In the Matter of)	
)	
EXELON GENERATION COMPANY, LLC.)	Docket No. 52-007-ESP
)	
(Early Site Permit for Clinton ESP Site))

NRC STAFF RESPONSE
TO LICENSING BOARD'S ORDER OF AUGUST 2, 2006

Staff Response to Clinton ASLB Order Dated 20060802

Seismic Open Items 2.5.2-4 and -5

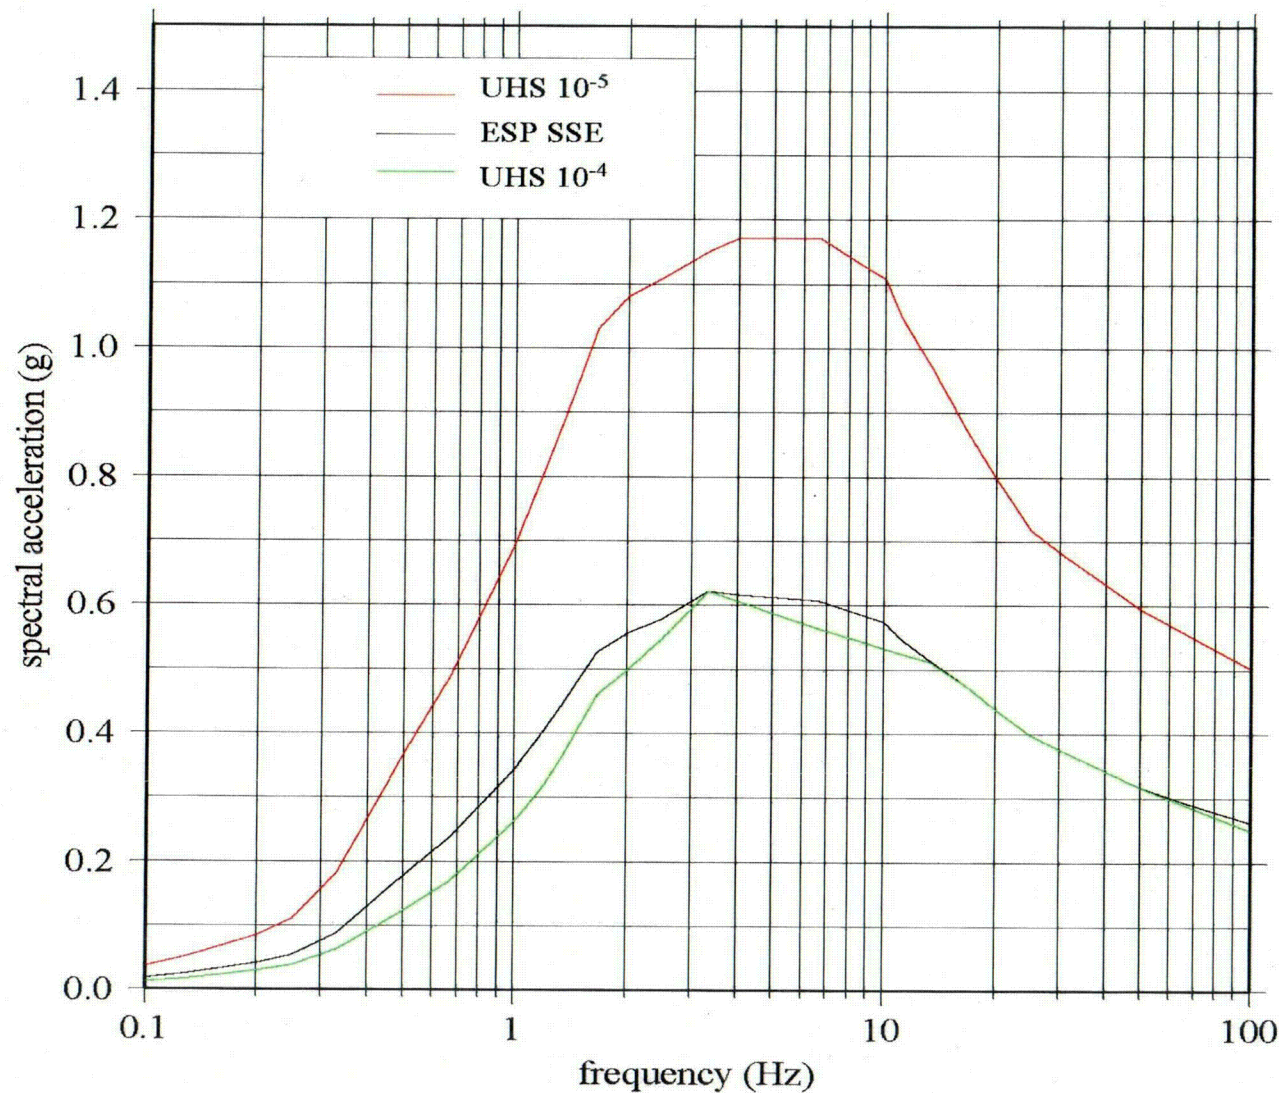
- Open Item 2.5.2-4:

- The performance-based SSE spectrum for the ESP site is approximately equal to the mean 10^{-4} uniform hazard spectrum
- The performance-based SSE at 10^{-4} may not adequately represent the seismic hazard from local earthquakes

- Open Item 2.5.2-5:

- Assumptions underlying the performance-based approach

Historical Seismicity and Estimated Centers of Large Prehistoric Earthquakes in Site Region

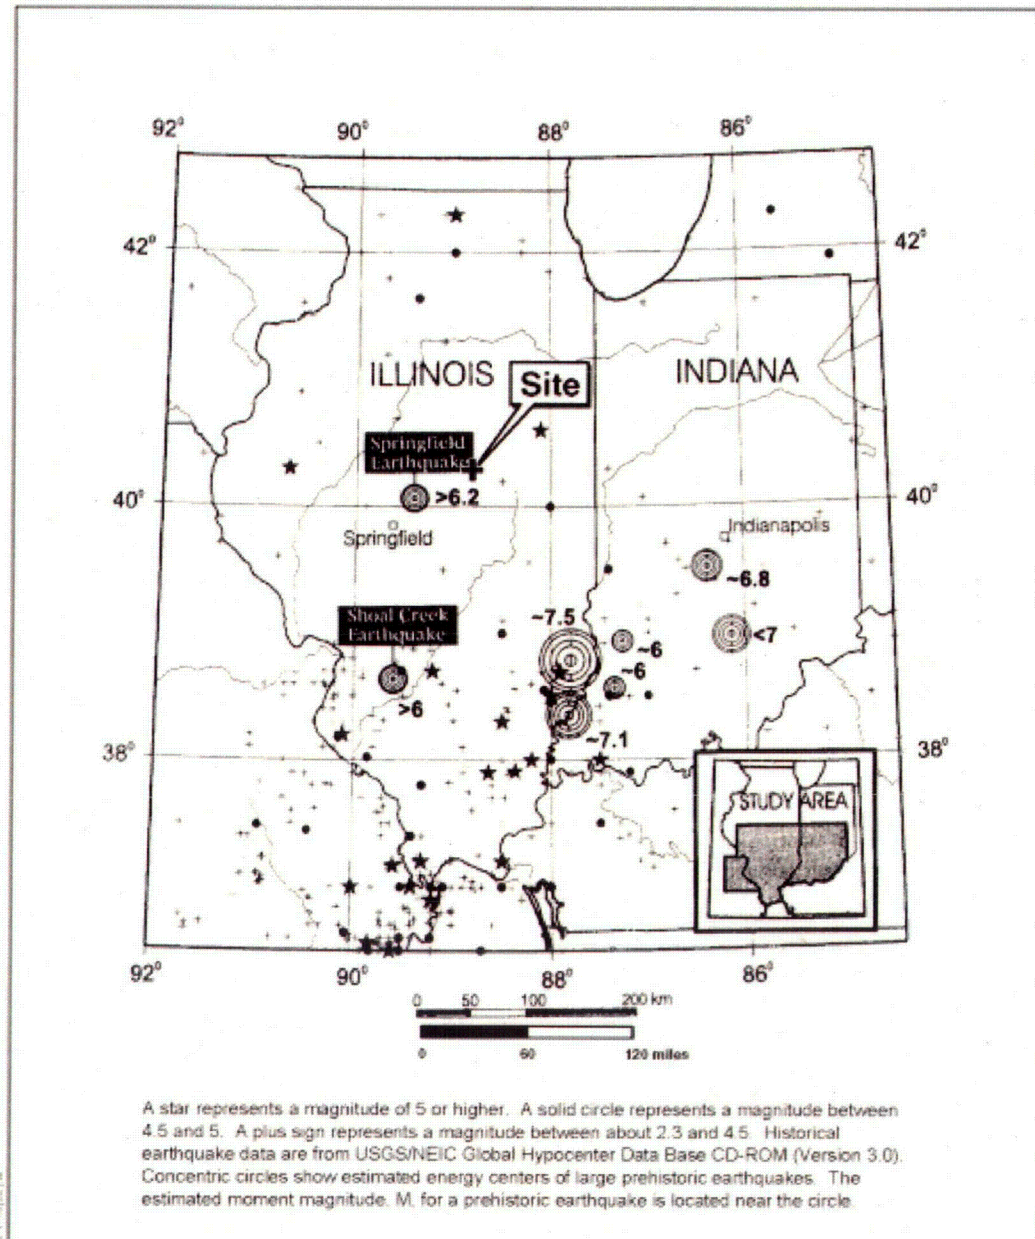
The performance-based approach with a target 10^{-5} annual performance goal may not be suitable for determining the SSE for the Clinton ESP site
